Boys & Girls Clubs of Central Texas

ADDENDUM NO. 1
for
**McLaurin-Boyd Campus Phase 2 Expansion –
Great Futures 2025 Project
ARPA 04**

Date: February 16, 2023

Sheet Number: M-2

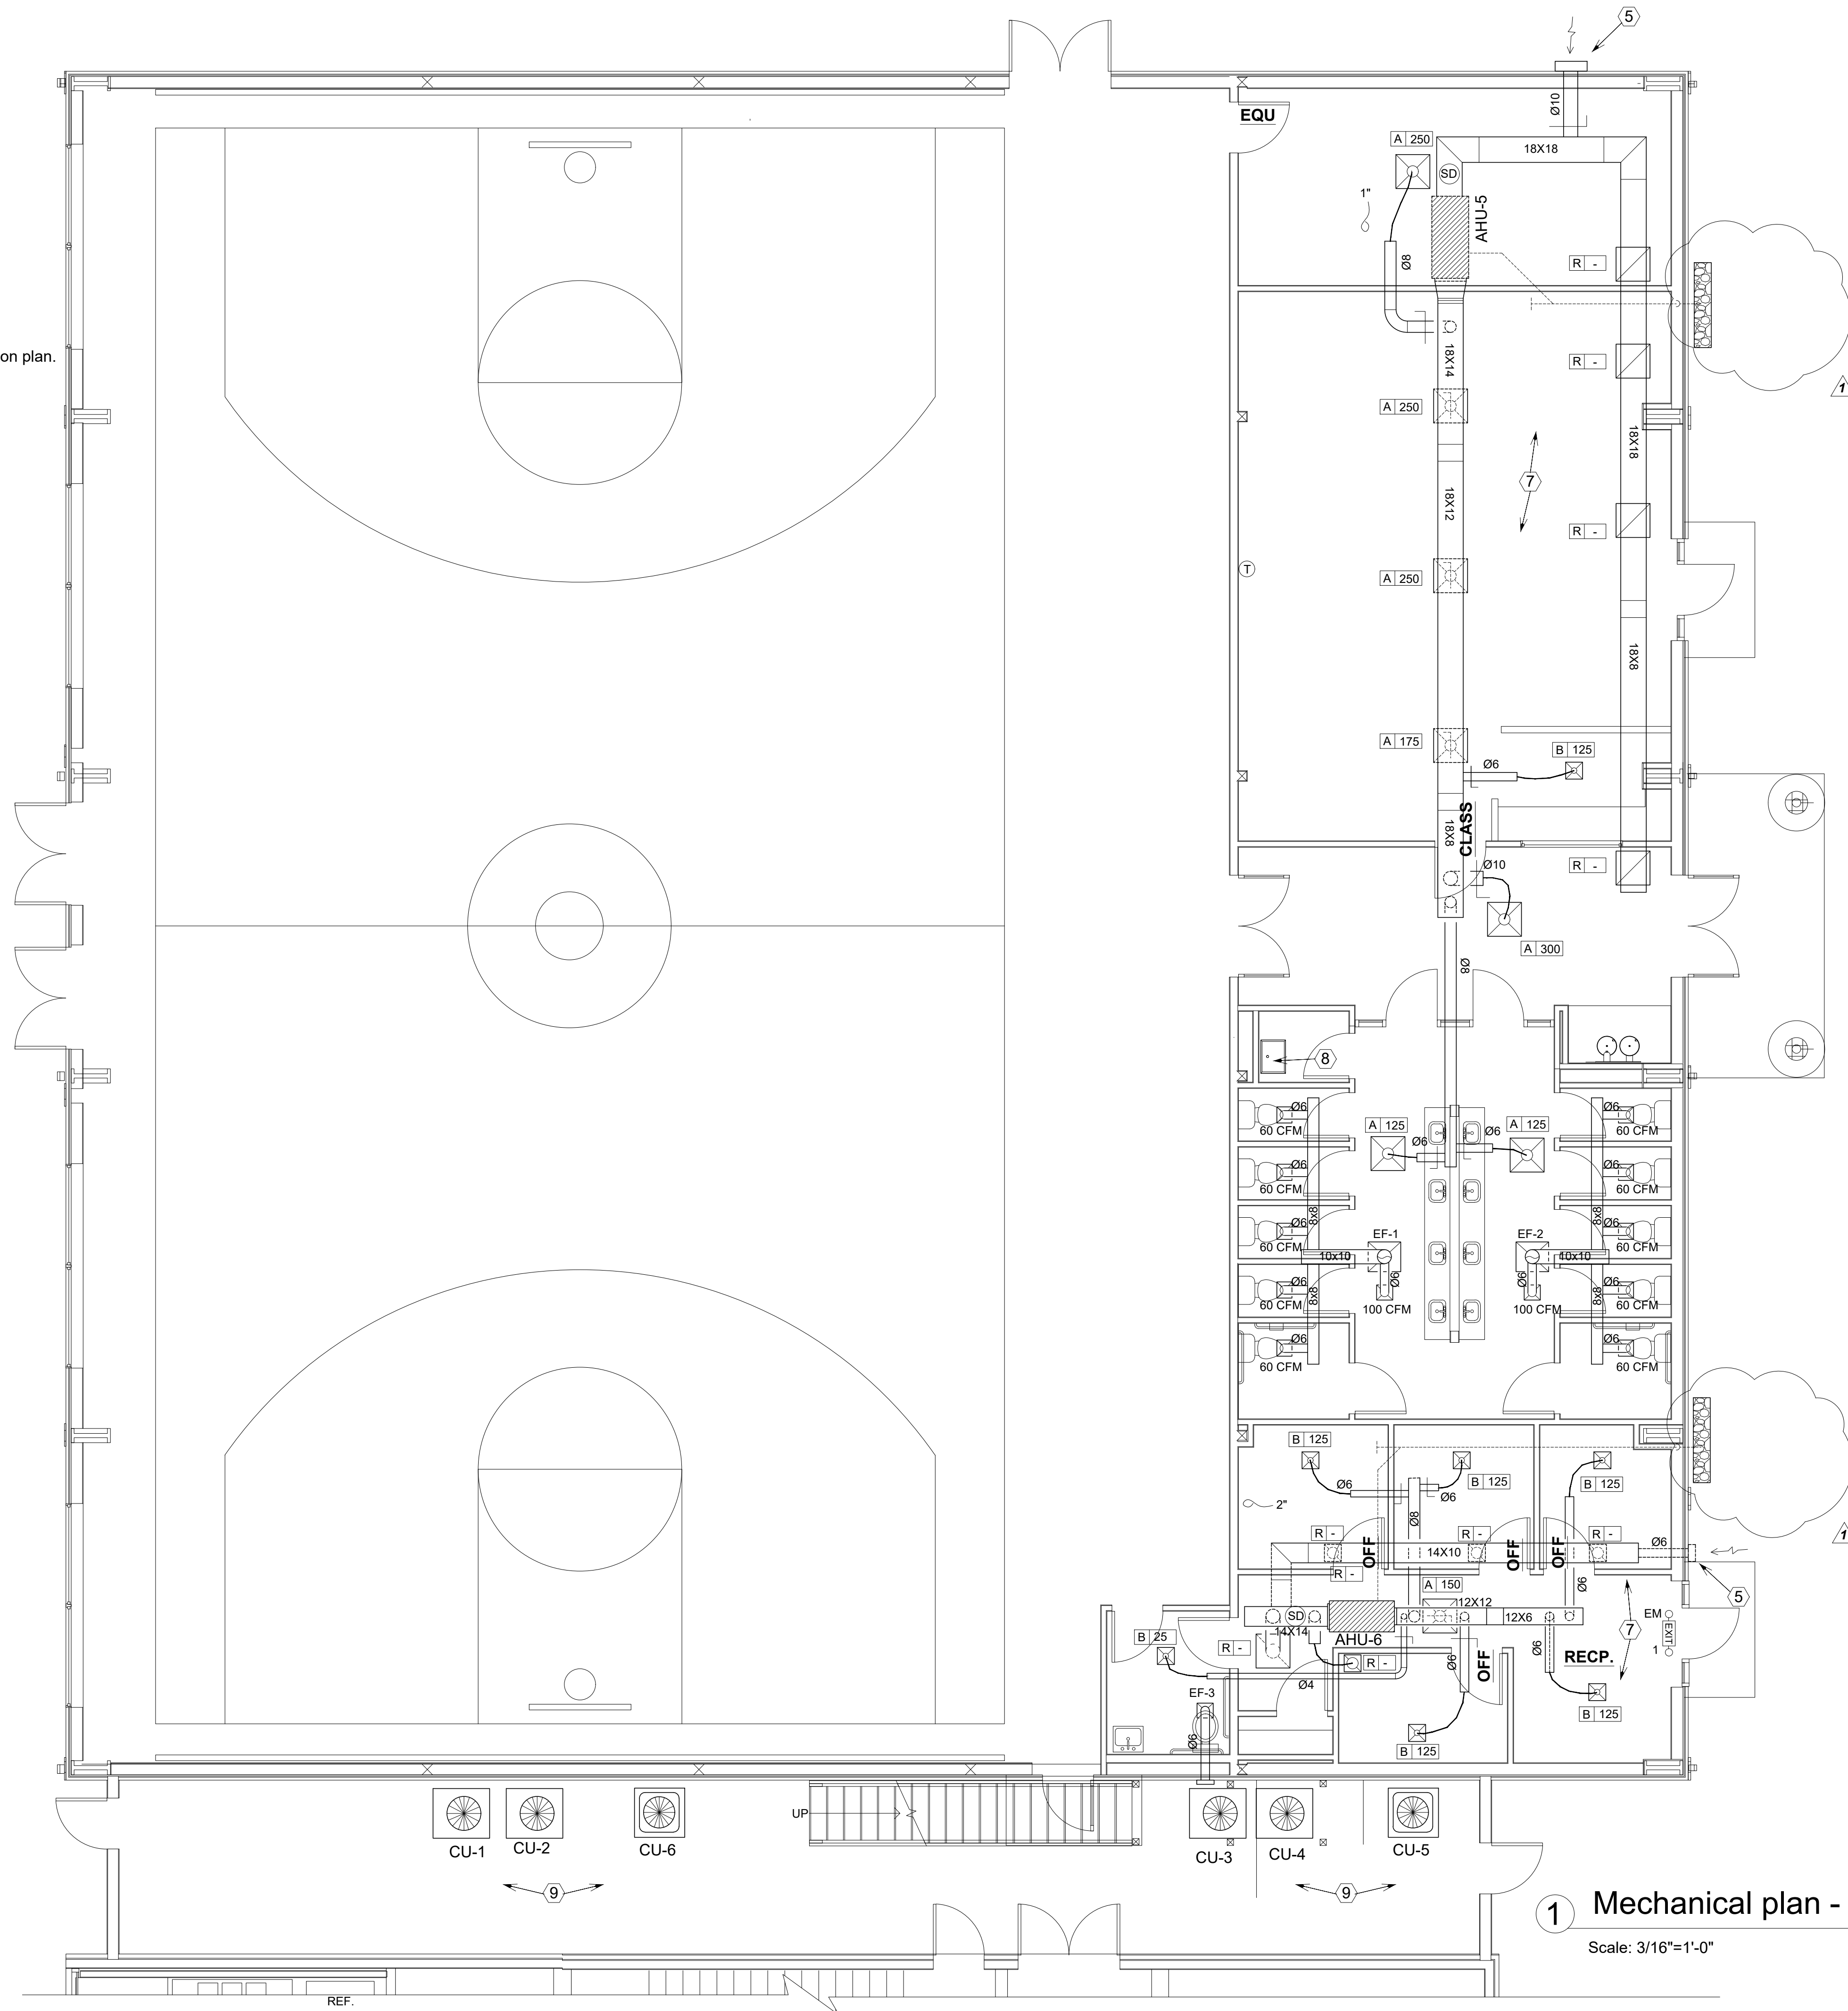
1. **Mechanical Plan Page – Gym Area HVAC duct... What is the size of the duct at the perimeter of the building?...the horizontal ducts are marked but nothing is marked for the perimeter duct size.**

See MEP addendum page m-1, m-2 and m-3.
